Breakout Rev[F] SCH to PCB Differences

The schematic on p35 thru p42 of the Breakout Operation, Maintenance, Service Manual (TM-058, 4th printing) shows Rev[F]. This schematic does not perfectly match Rev[F] circuit boards. This document details the differences. Naturally we modify the schematics to match the boards because the boards ... work.

Diff-1 @ [S#1-C6]: Suppress LH/RH during HSYNC (adds CR9*, CR10*, R59*)

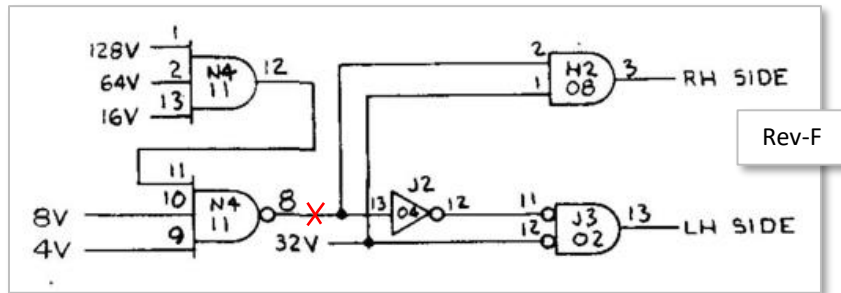
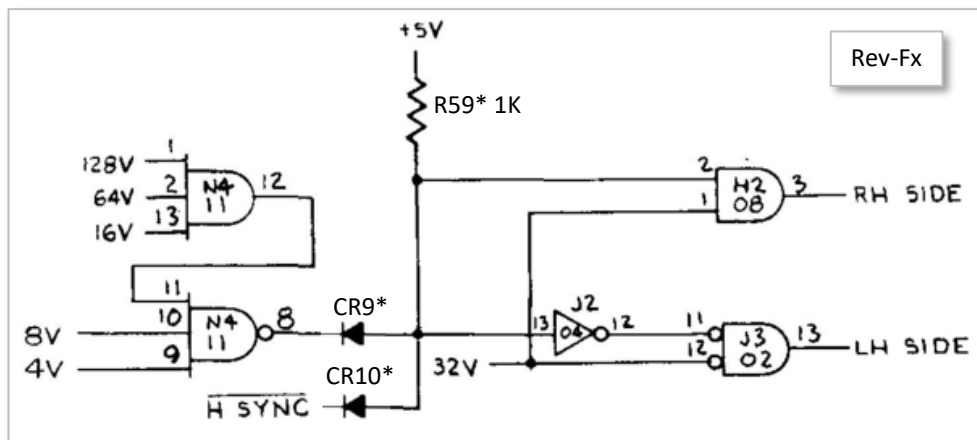
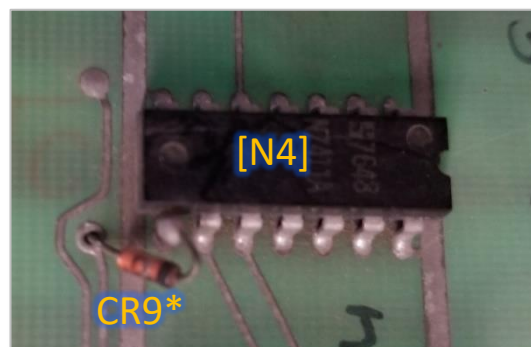
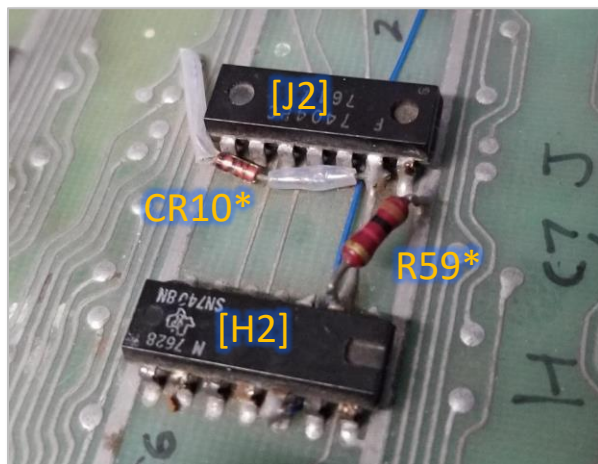
Net was cut and two diodes and a 1K resistor were added, effectively creating an AND gate (or negative-input NOR) to suppress LH/RH sides during !H_SYNC.

You can see part of this mod on the rev-D board as shown below. This is built into rev-E boards. ECN therefore should be 2525. Diodes are 1N914 and the resistor is 1K.

Diff-2 @ [S#1-A6]: Different wiring of the Set Bricks FF [D3b]

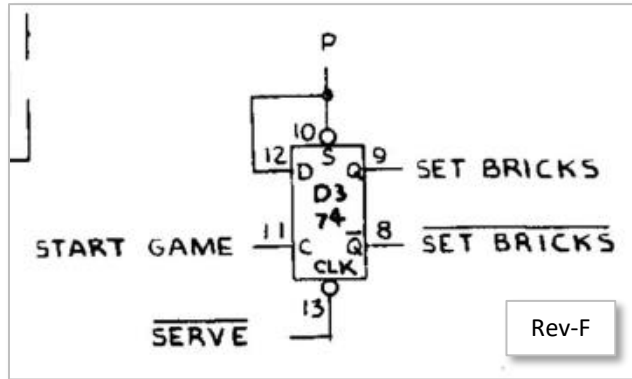
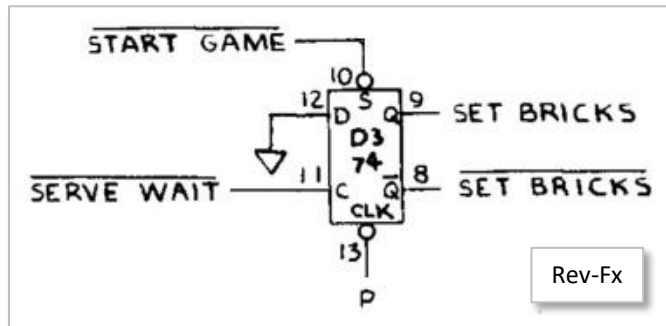
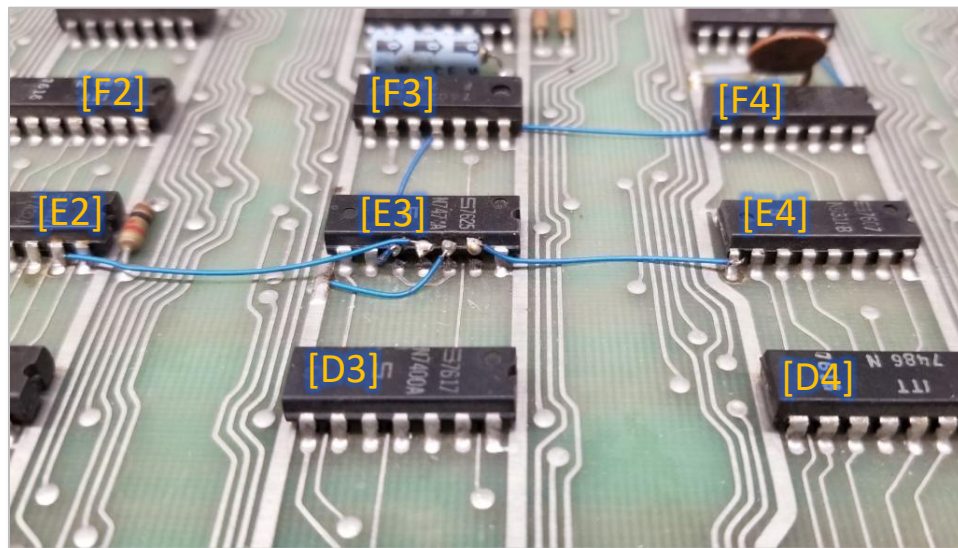
The set bricks driver FF is wired like this on the schematic:

But is wired like this on the PCB. Note that pin 13 is labeled CLK but is clearly CLR.

You can see change this was a mod to a Rev-C board, but is present in boards >= Rev-D:

Diff-3 @ [S#1-D3/D4] - Video Chain Resistor Differences

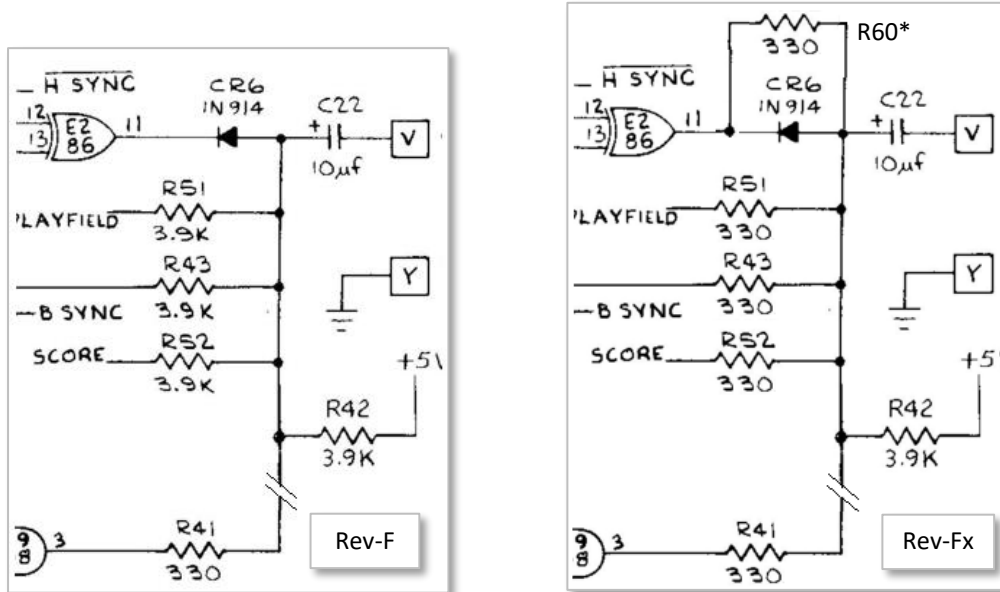
R41, R43, R51, and R52 on my ref-D board and in subsequent images are 330 ohms (R42 remains @ 3.9K). This increases the white level of the video signal. Another 330 ohm resistor was also added over CR6 (effectively removing CR6 function).

You can see the new resistor soldered over CR6 on my ref-D board (left) and a new place for this resistor on a rev-E board. Again, the ECN should be 2525.

Diff-4 @ [S#1-C2]: Play FF [F5a] Cleared by HSYNC instead of 128H

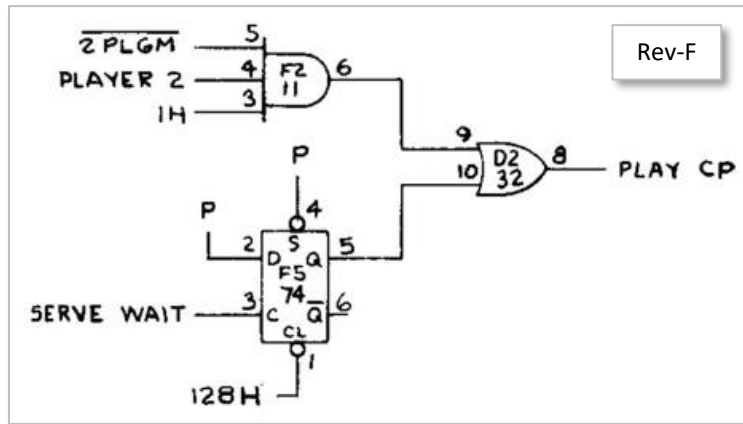
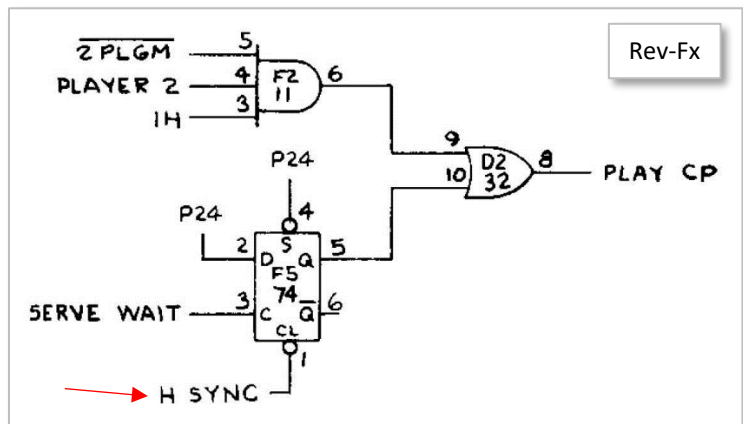
FF Clear is driven by 128H on the schematic.

But is wired to H_SYNC on the PCB

Diff-5 @ [S#1-B4]: Different Wiring in Ball Motion Logic

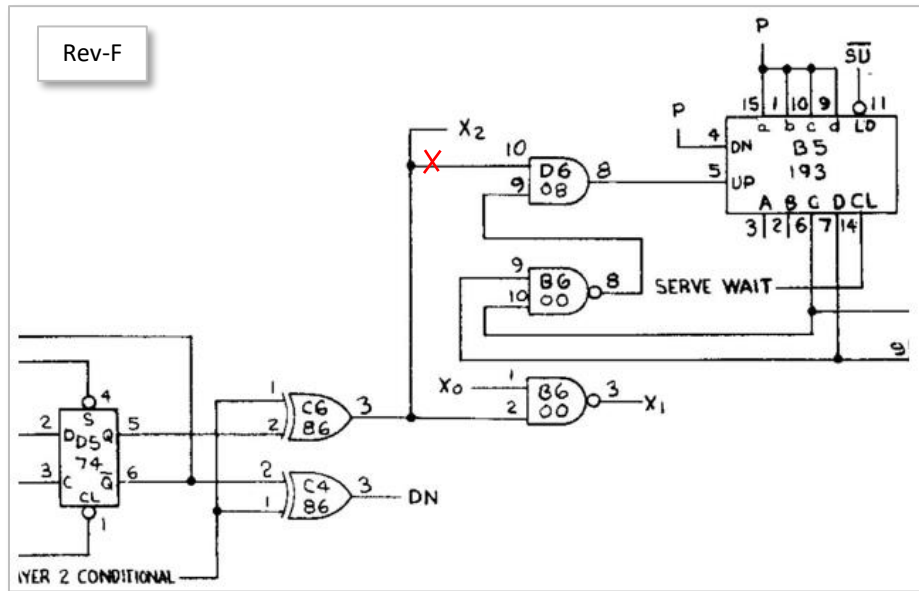
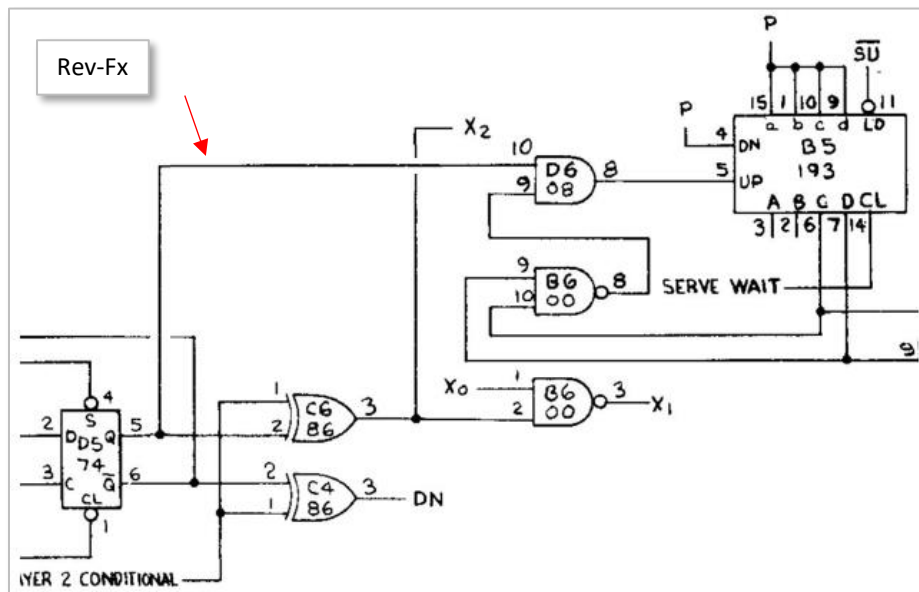
X2 into D6.10 comes off C6.3 on the schematic.

But D6.10 is driven by D5.5 on the PCB. This only takes effect when player 2 is up on a cocktail machine. Using the rev-F schematic, the ball is shot quickly towards player 2. We don't see this behavior in FPGA derivatives because 2-player cocktail models are never implemented (that I've seen).

Diff-6 @ [S#1-B1/2]: Serve Wait Logic Differences & Add 330pF Cap C39*

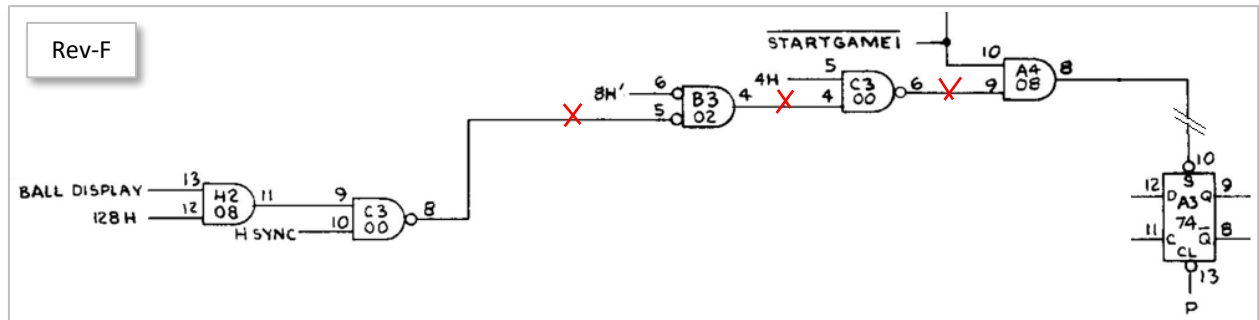
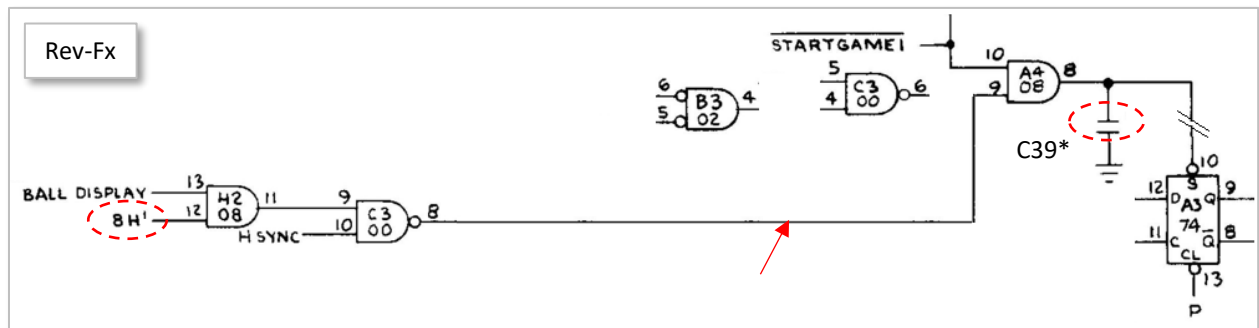
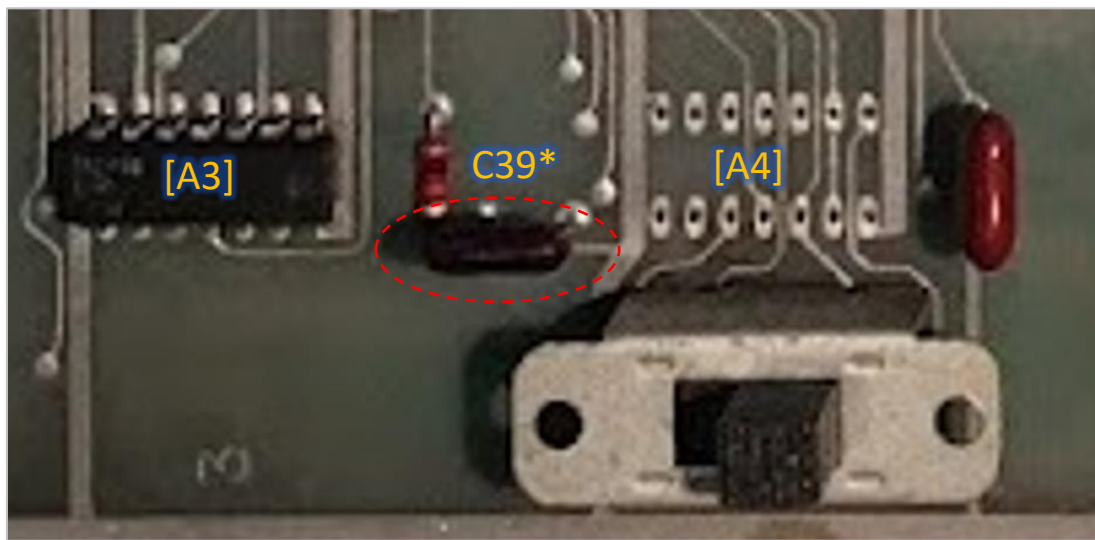
The serve wait FF [F3b] set logic looks like this in the schematic.

But looks like this on the PCB. Gates B3b(4,5,6) and C3b(4,5,6) are unused on the PCB (inputs should be tied down or pulled up). Gate H2 pin 12 is tied to 8H' on the PCB, not 128H as shown in the schematic.

There is also a cap present at site A3/A4 on ref-F board shown below, connected to A4.8 as shown in the revised schematic above. This is not present on my Rev-D (mod or otherwise), but is present as a mod on #3877 (assume rev-E). No clue what the value is. Looks the same as the other 0.001uF caps, e.g. C37.

Diff-7 @ [S#1-B1/B2]: Another Serve Wait Logic Difference (adds a 7408 @ [C1*])

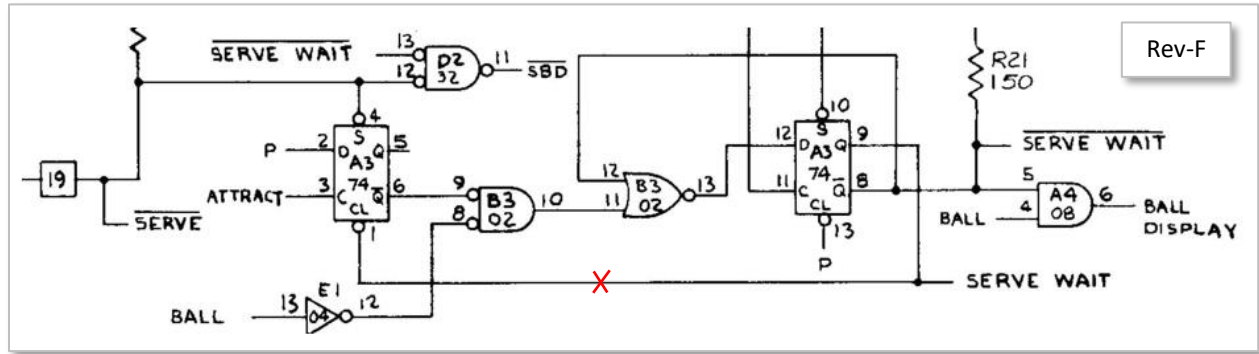
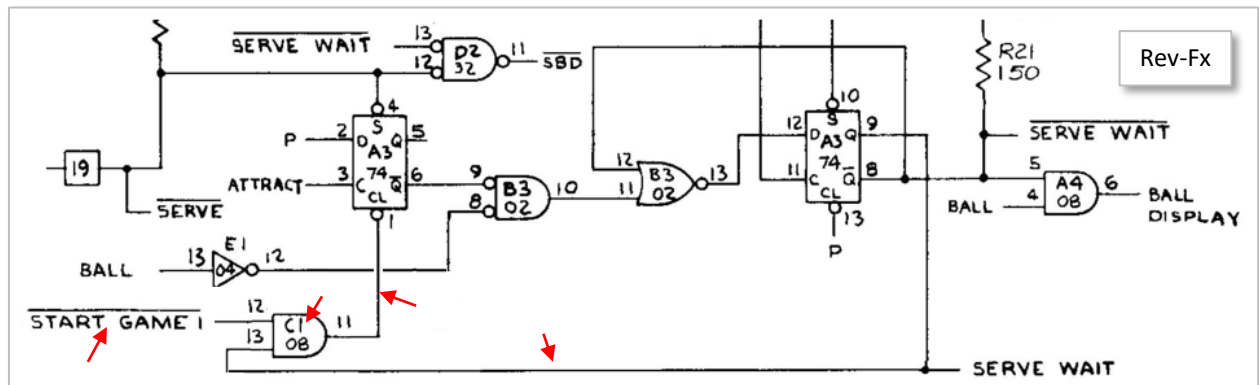
Site C1 is clearly populated on most PCBs but there are no C1 gates on the schematic. Only one gate is used. This mod allows the !START_GAME signal to reset FF A3a (blocks ball from attract mode). This modification is present in many early boards.

Logic as present in the schematic. A3a's CLR is wired to the SERVE_WAIT signal driven by A3b-Q.

Logic as present on the PCB. Both SERVE_WAIT and !START_GAME_1 drive A3a's reset pin.

Left: Site C1 added and modified on Rev-C. Right: Site C1 built-in PCB on \geq Rev-D.

Diff-8 @ [S#2-B2] - Paddle Wiring Differences

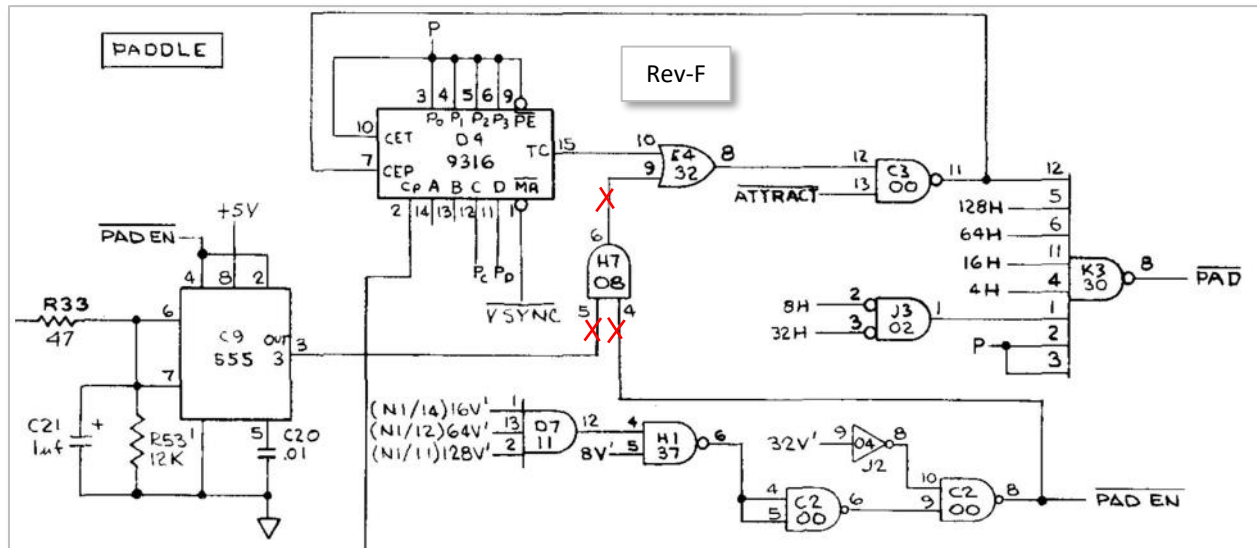
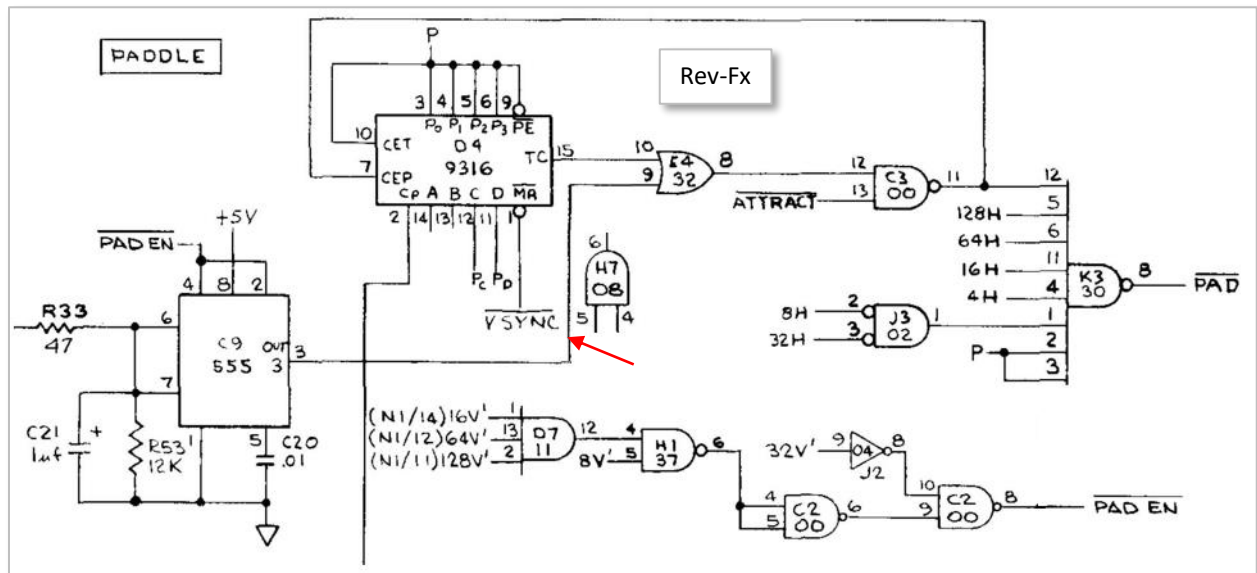
Schematic shows the output of C9 wired to H7.5

On the PCB, C9.3 is wired to E4.9 as shown below and gate H7b (4,5,6) is unused.

Diff-9 @ [S#2-B3] Paddle Timer Changes to 555 @ [C9] (adds C40*)

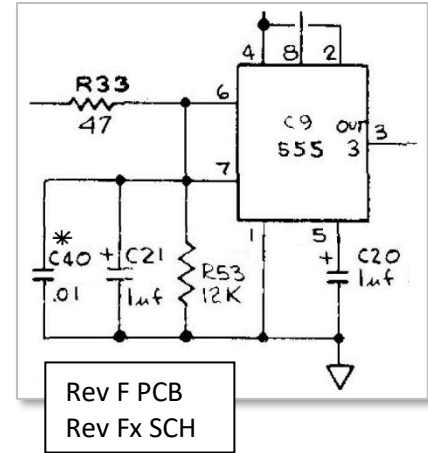
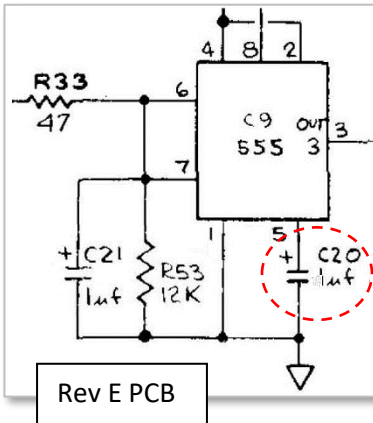
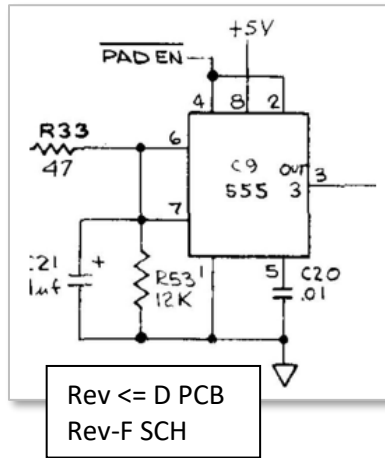
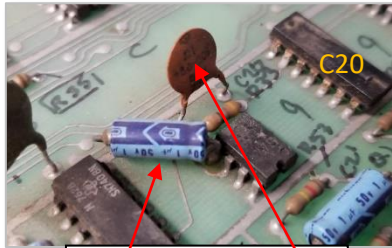
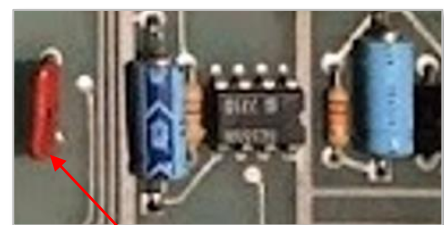
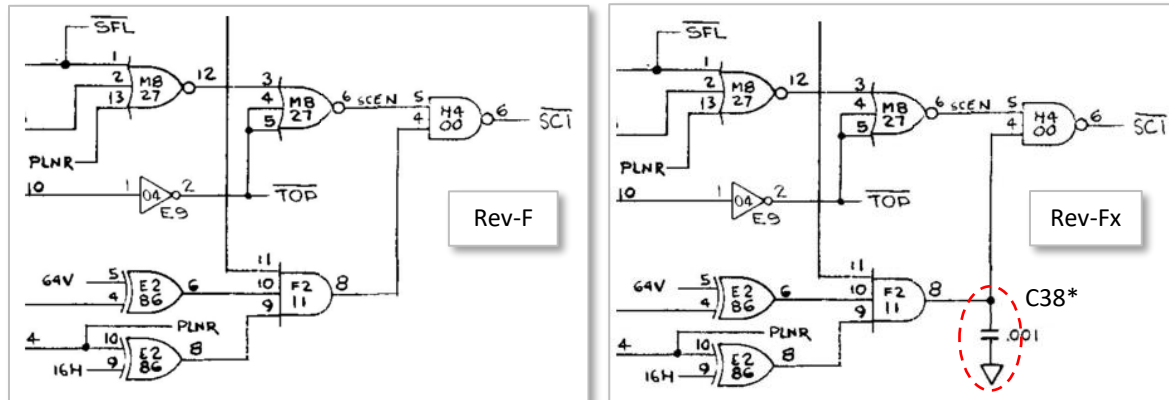
Schematic shows only one cap on L9.5 but the PCB and mods have 2. From the board images it looks like they first changed C20 to 1uF in Rev-E (but still 0.01 in Ref-F SCH), then added C40* in Rev-F.

Here are board images showing a Rev-D with 1uF mod (over) C20, a Rev-D board with C20 changed to 1uF on the PCB, and a Ref-F board with an additional 0.01uF cap (C40*) on the input line.

- In <= Rev-C the timing component values were different: R33 was 100ohm, C21 was 2.2uF, and R53 was 47K ohm.
- In <= Rev-C [C9] pin 2 (!RESET) was driven by !V_SYNC , not !PAD_EN.

Diff-10 @ [S#2-A4]: Add 0.001uF Capacitor in Score Logic (adds C38*)

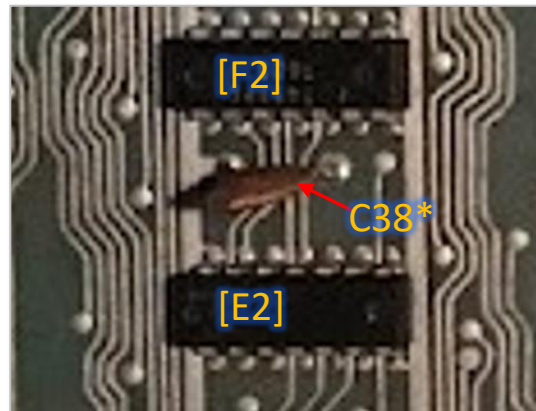
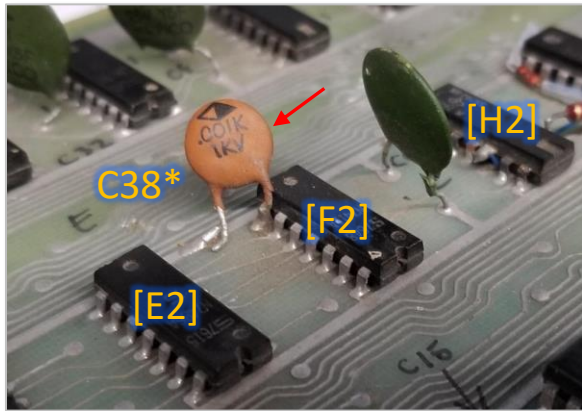
The PCB has a 0.001uF capacitor on K2.8 that is not shown in the schematic.

This is a modification on the rev-D board but is built-in on the ref-F board between [E2] and [F2]

Diff-11 @ [S#3-C7]: 1-Credit Start FF Wrong Signal Marking

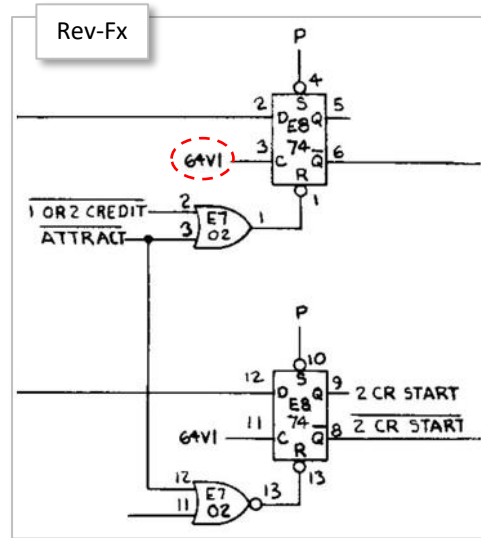
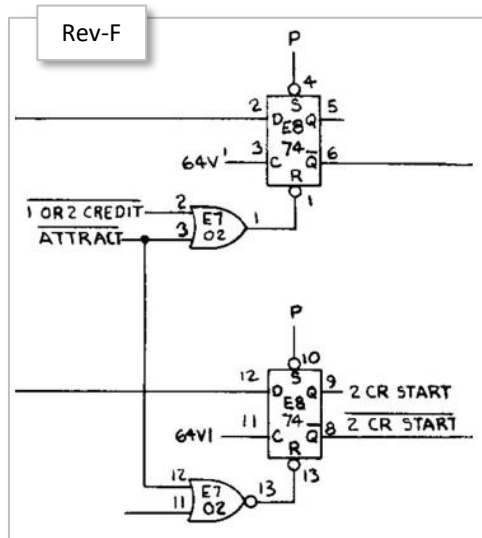
Schematic shows 64V' going into E8a.3 (FF clock) but this is 64V1 on the PCB. This is the same signal going into E8b.11 (FF clock). My guess is that they intended to use 64V' on both of these clocks because there is absolutely no reason you would want to change this coin logic signal when player 2 is up on a cocktail table.
